STATE OF MAINE
DEPARTMENT OF TRANSPORTATION
16 STATE HOUSE STATION
AUGUSTA, MAINE
04333-0016

January 18, 2007
Subject: **Topsham**
Pin No. 14062.11
Amendment No. 4

Topsham
14062.11
Highway Maintenance Garage
January 16, 2007

MAINE DEPT. OF TRANSPORTATION
 BUREAU OF MAINTENANCE AND OPERATIONS
NEW MAINTENANCE FACILITY
 TOPSHAM, MAINE
SITE UTILITIES PLAN - EAST

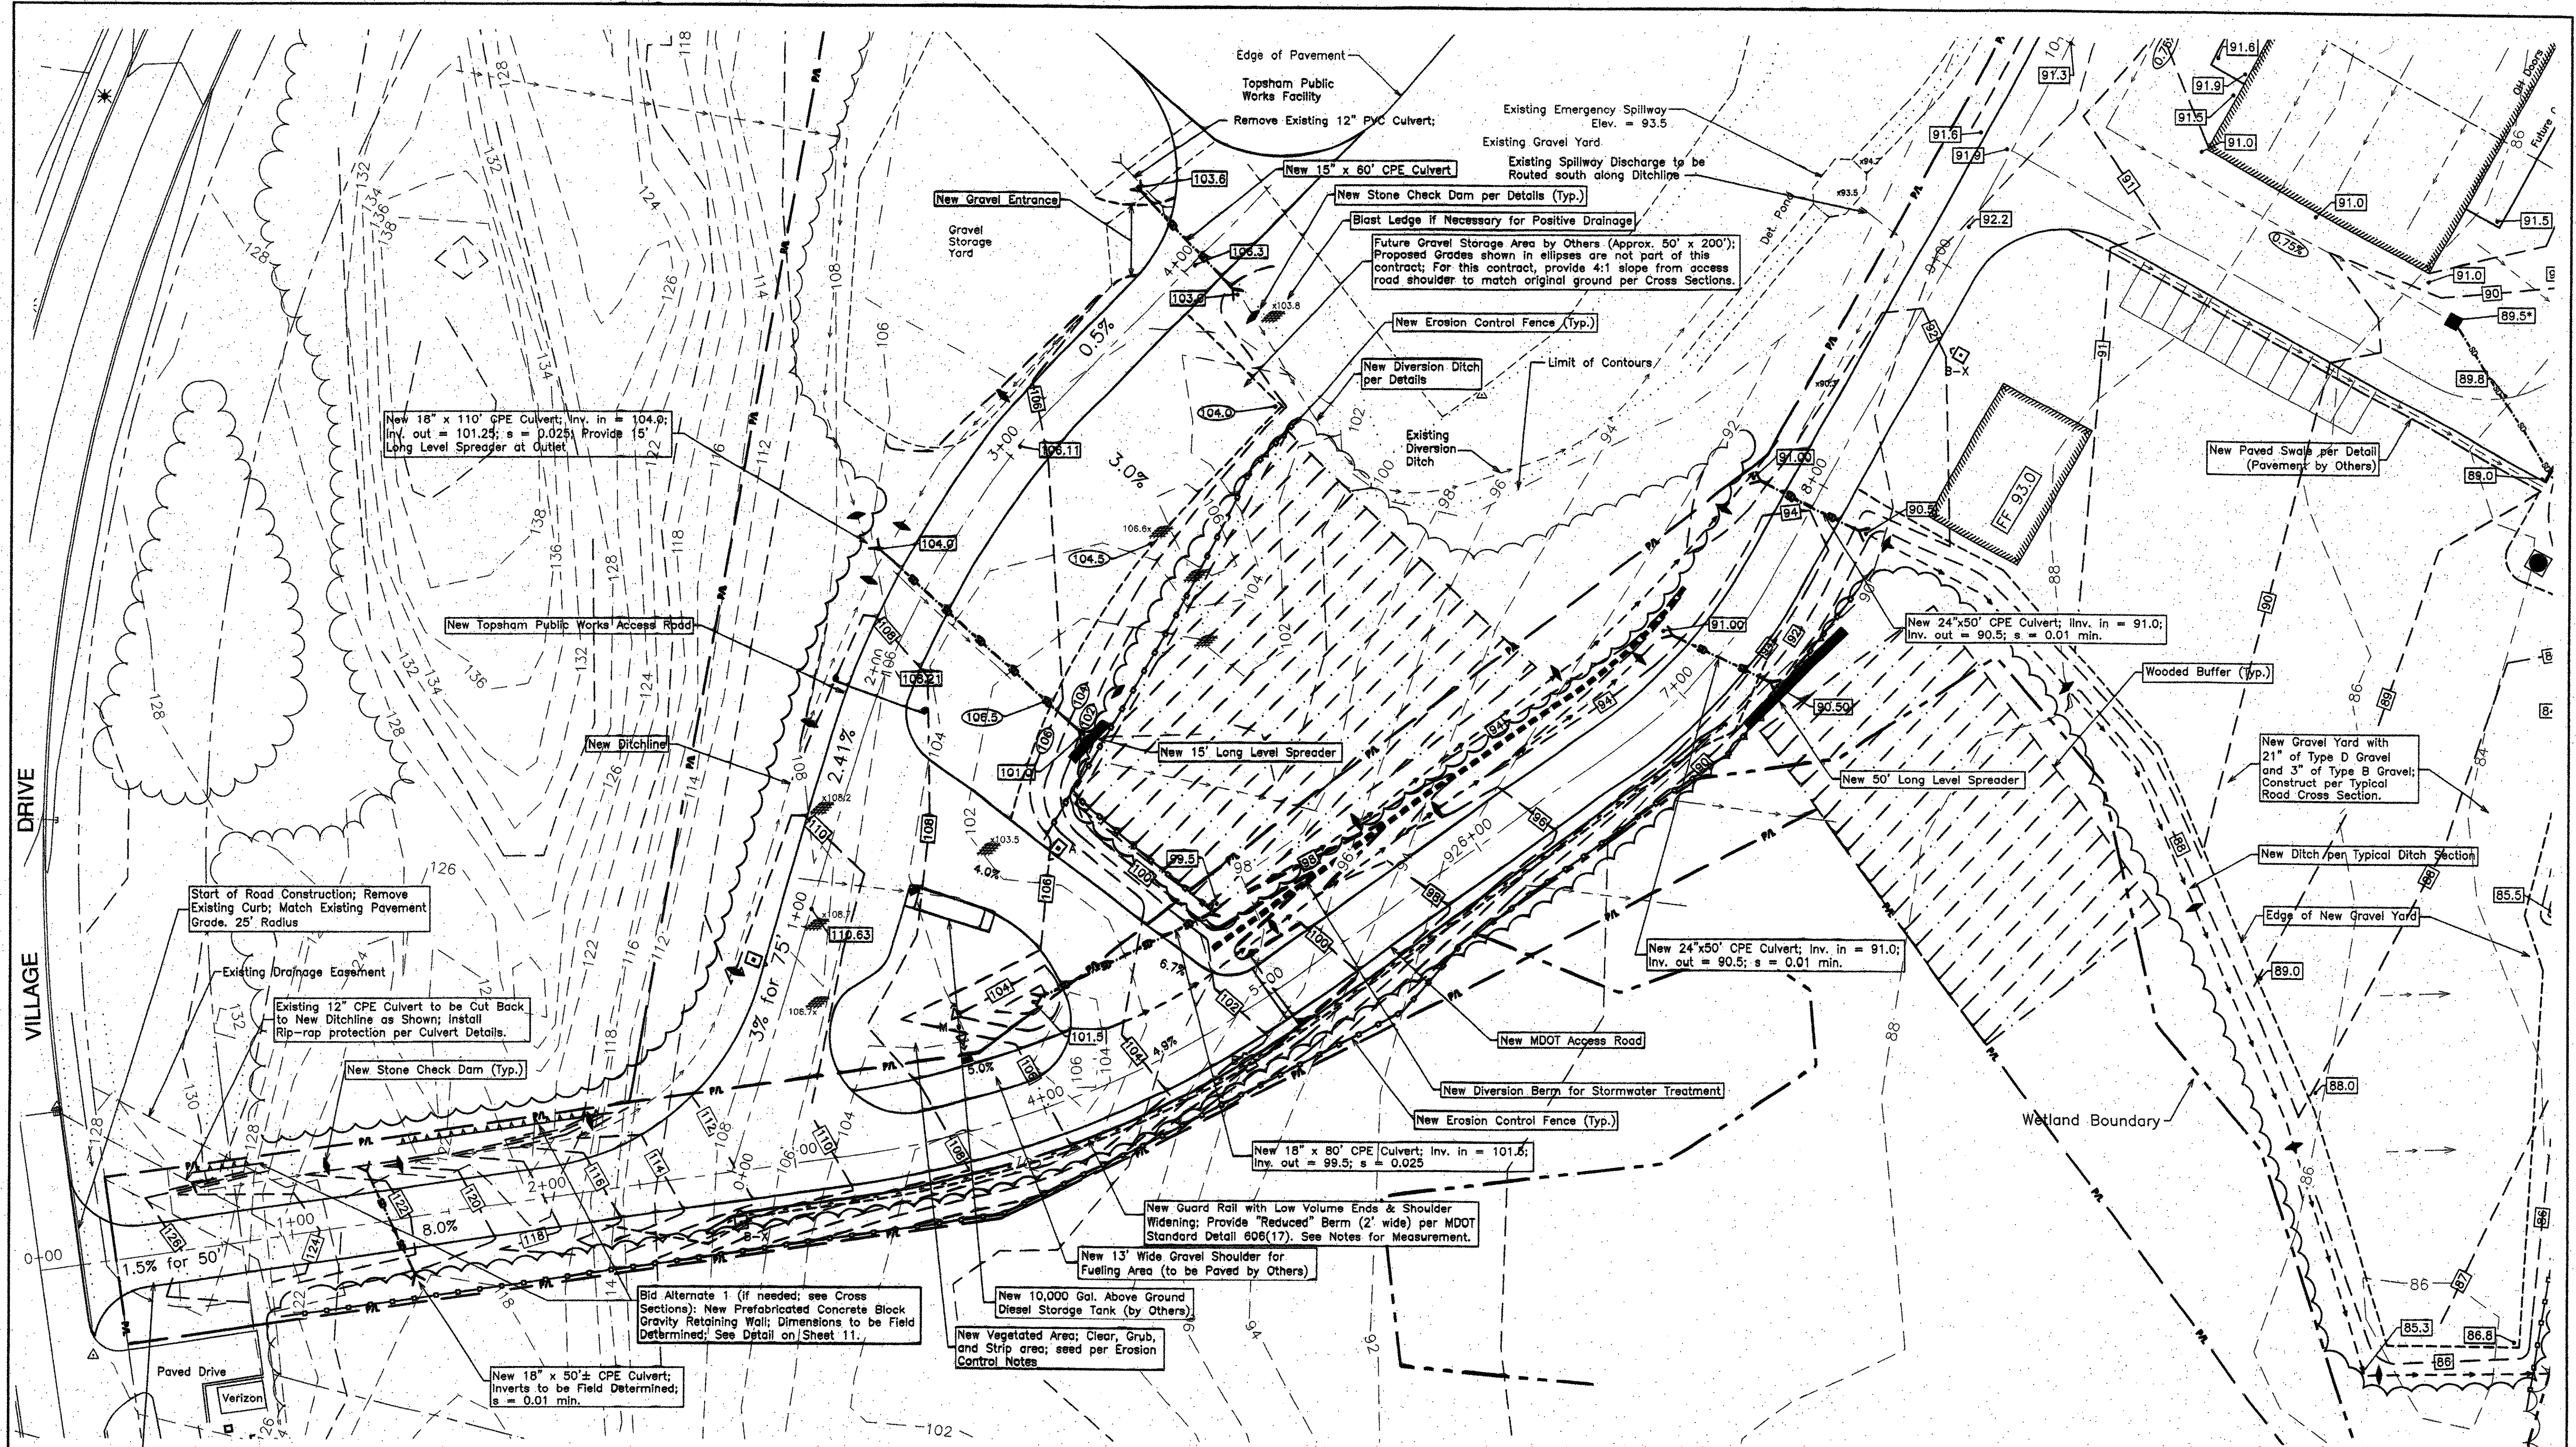
Question: Is it the intent of the drawing to show that the Electrical Primary feed is already within the property boundaries and stops where the bold line on the drawing begin?

Question: Can't find reference to where existing Pin 14062.10 work ends and 14062.11 begins on prints.

Response: The contractor’s work will begin where the existing PIN 14062.10 Topsham Maintenance Facility Site Work Project ends. Please see revised Special Provision Section 16410 Electrical Work, 2.15 “Electrical Service and Distribution System”

Response: Refer to the attached sheets 3 and 4 of plans for project 14062.10 but field modifications have been made to project 14062.10 .
